# PERALTA COMMUNITY COLLEGE DISTRICT

## MERRITT COLLEGE NEW LANDSCAPE HORTICULTURE INTERIM HOUSING

BID NO. 21-22/11

### ADDENDUM No. 1

### **1.2 SUMMARY OF WORK COVERED BY CONTRACT DOCUMENTS**

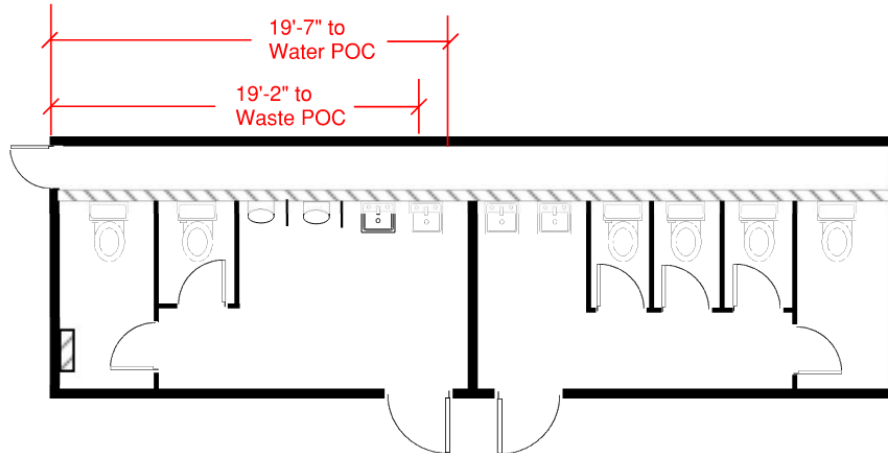
A. The Work of this Contract consists of, but not limited to, the following:  
This project consists of placing DSA approved PC (stockpile) modular units at an interim housing complex comprised of (3) classrooms, (1) office, and (1) multi-stall restroom unit for the Merritt College Landscape Horticulture Program, with all associated site improvements. All buildings are single story. Occupancy classifications include B. Construction type is V-B. Seismic zone E.

\*\*\*Occupancy Classification “and E” and “fully sprinklered” have been removed.

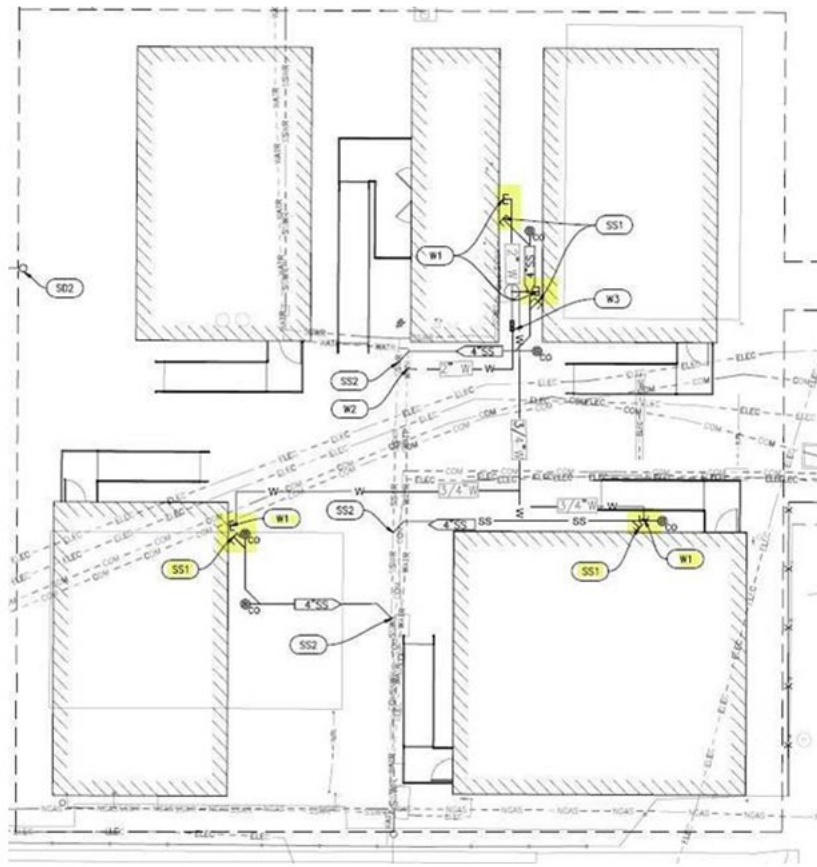
4. Please see the portable restroom 12' x 40' elevation immediately below. The water and sewer point of connection will be above finished floor.

Per the next image below, the points of connect for water and sewer for the classrooms, the points of connection will be done on the side walls of each classroom. The water and sewer connections will be above finished floor as well. Because these points of connection will be on the side wall Mobile Modular cannot provide the stub outs to the General Contractor to connect. The reason being is because the stub outs will make the modular sections over width when being transported to the site. Therefore, Mobile Modular will ship the stub outs "loose" so the General Contractor can install, then connect to water and sewer.
